Serial No.: 09/762,223

Title: **DEVICES AND METHODS FOR THE REPAIR OF ARTERIES**

**COMBINED PETITION UNDER 37 CFR §1.181(a)(1)
TO WITHDRAW PREMATURE FINAL REJECTION /
TO WITHDRAW HOLDING OF ABANDONMENT
(37 CFR §1.113(a); MPEP 706.07(c))**

Figure 10

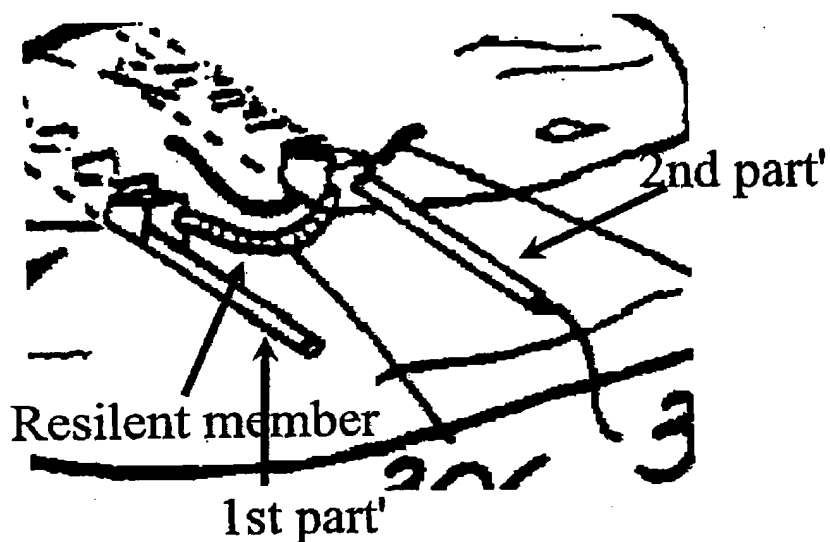
14. The applicant describes a helical structure in part C, yet there is no mention of a helical structure in the specification and no support in the diagrams to substantiate the claimed subject matter.

The stabiliser (Fig. 10) consists of two elastically deformable thin strips of metal (47) which, when unconstrained form a nominally circular shape (46). The two strips are riveted together (45) at the leading edge and are riveted onto a short metal tube (49) which has been arranged to retract within a catheter sheath (48). **The metal tube (49) serves as a locating member for locating the device with respect to a catheter, and the distal portions of the strips (46) define support members (320) for supporting the catheter on the inner wall of an artery or graft. The proximal portions of the strips (46) then serve as resilient members (322) which connect the locating member (49) and the support members (320), with the resilient members (322) biasing the support members (320) toward the artery wall. As the resilient members (322) bias the support members (320) toward the artery wall, they reduce the distance between the end of each support member (322) and its resilient member (322), thereby causing the support member (322) to bow radially outward with respect to the locating member (49).**

Figure 14

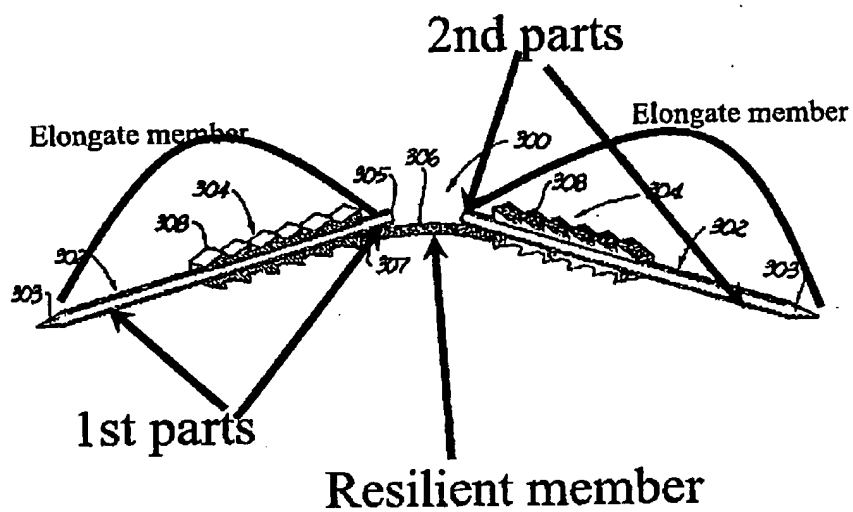
17. Regarding claim 68, the elongate member of the Green device has the capability of being in an open configuration, figure 14, and a retaining configuration, figure 1, where in the 1st and 2nd parts are closely spaced, wherein the device is biased towards the closed configuration. Further, the elongate member extends between the first and second element and is connected between the first and second ends. The modified Green device could be inserted into a graft-bearing artery to pierce the graft and artery. Once the device, part 1, is completely pushed through the artery, the graft and artery would be maintained between the first and second part where in the device would be in the closed position.

18. Regarding claim 69, the fixator has 2 parts that are sharpened, allowing it to pierce an artery and a graft (see figure 14).

Reconsideration of the rejections is requested.¹ Initially, note that claim 68 recites elongated members (in the plural). If *Green* is regarded as having a pair of elongated members 302/303/308/304 (as shown in the Examiner's second drawing in the Office Action), *Green* neither discloses nor suggests bending each of the elongated members as recited in claim 68; rather, each elongated member stays straight, with the bioresorbable connection between them (see column 8 line 62 onward) being bent. Note that the Fig. 10 apparatus is shown "spread" merely because the bioresorbable connecting material is not rigid, and that the apparatus is not in fact bent when deployed: as depicted in Figs. 7-9 and described in the specification, the *Green* apparatus is driven forward in a U-shaped form, see Figs. 13 and 14, with each "arm" being in parallel and being driven by needle 302, see Figs. 13 and 15, and the apparatus remains in this configuration when deployed, without the spacing between the arms being varied. After deployment, the bioresorbable connection between the arms dissolves while the arms remain in tissue as retaining spikes (see, e.g., column 10 lines 55-60). Thus, *Green* has no teaching or suggestion that a fixator may include an elongated member (much less multiple elongated members) wherein each elongated member is bent from a linear form to a form wherein its ends are closely spaced, such that each elongated member retains a graft and artery together. *Green* is simply a rather conventional surgical staple having linear arms which remain in linear form when installed in tissue, but the "bridge" of the staple is made of dissolving (and flexible) material. Consider that this flexible material cannot maintain the arms in a closely spaced condition (and in fact it cannot hold the arms in any fixed location owing to its flexibility), and thus there is no way to use the *Green* apparatus to fix an artery and graft in the manner claimed, nor is there any apparent reason why one would be motivated to modify the *Green* apparatus to provide this capability. In

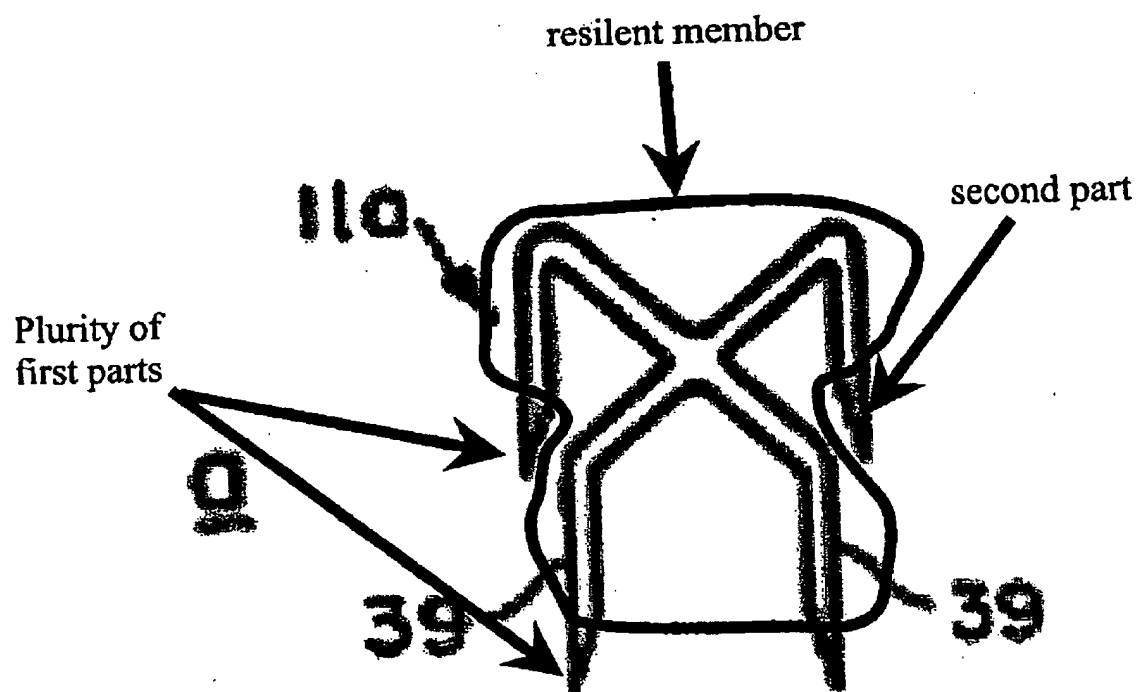
15. Regarding claim 63, the Krumme fixator can hold a graft.
16. Regarding claim 64, the Krumme device illustrated in figure 5a contains two elongated members (one elongated member has been painted gray in the attached diagram, the other one is white.) The elongated members have an open and closed configuration. In the open configuration, the first and second members are spaced; in the closed configuration, the first and second members are closer together.
